Subject: Re: NPT requests for exemption

Exception Request No:	18
Section:	WBR3
Town:	Campton
Highway:	US 3
Station:	2373+55 to 2384+52
Drawing No.:	WBR3048-01 TO WBR3048-3 and WBR3 C205 to C206
Exception Type:	HDD Pits with Pavement HDD Alignment Passing Under Pavement

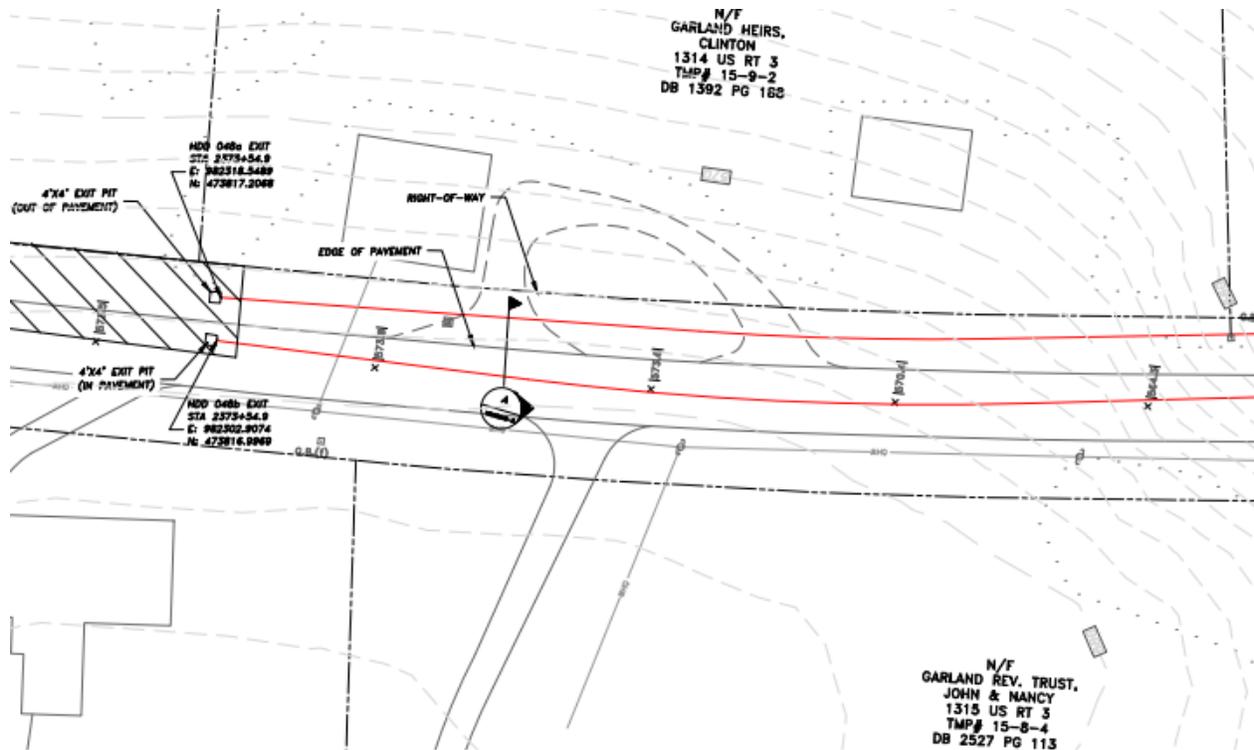
I am wondering why exception #18 was rejected because the ROW appeared to be of the lowest quality, when this can be said of every exception map presented as well as all the Permit Packages.

This exception to the UAM is hereby **rejected and must be resubmitted** to address the following concerns.

1. Existing NHDOT Right-of-Way (ROW) appears from the survey report to be the lowest level of accuracy – GIS/tax map quality.
2. Bridge structures including deck, abutments and piers should be shown on the plans in order to evaluate potential impact.

Above is the Permit Package map from Exception Request 18. I see no difference between this and the map for Exception Request 39, below, where people will not be eating at the restaurant, (I believe it is the Sunset Grill) for weeks if HDD is permitted, even outside the proposed parking lot location. This map raised no comment on the accuracy of the ROW though it passes through two structures and exceedingly close to the restaurant. I see no DOT concrete monuments referenced here.

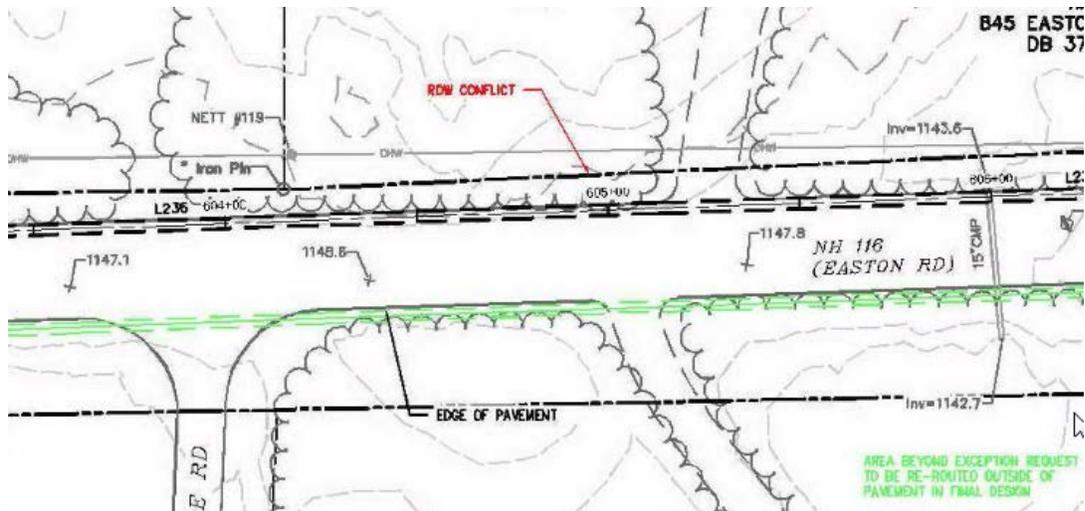
Above, screen shot from exemption request for HDD at Gibson Rd. exit. ROW here is undetermined or 40'. DOT set a prescriptive ROW here of 3 rods and specifically stated that this did not apply to Northern Pass. At the time this provisional prescriptive was set DOT was unaware that Easton used to be Lincoln and therefore unaware of the road layouts in Easton that are in the Lincoln records, specifically the 1804 layout of unspecified width, and the 1811 layout from Kendal Brook to Stephen Kinsman's saw mill (at the Ham Branch proposed HDD) that was laid out at 40'.

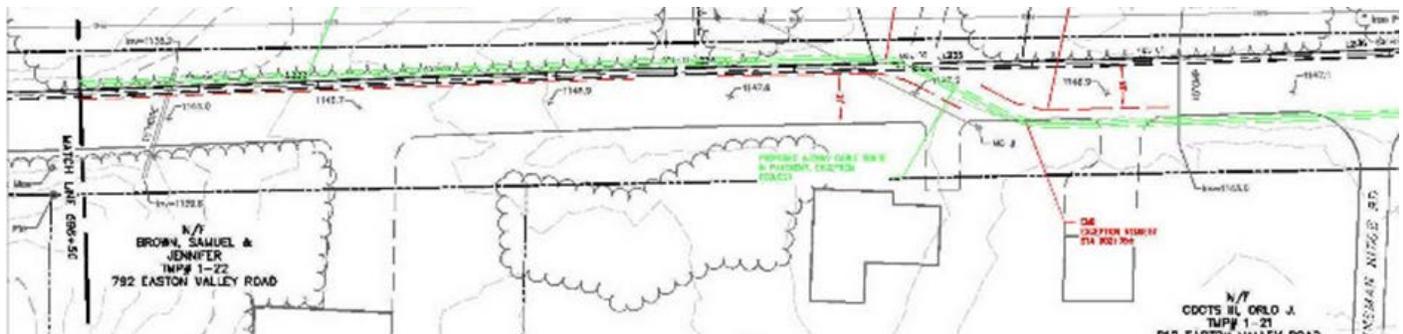
A bit north, NPT sets a road ROW boundary based on one property marker. No markers were found on the other side of the road, so the trench is proposed to be moved over there. Does DOT accept this? Are your ROW people kept out of the room where these decisions are made? And the supposed ROW set by this one pin then drifts on either side...

There is also no documentation for why the pin was held below, on the west (lower) side of the road (far left) while the monument, closer to the road, was not...
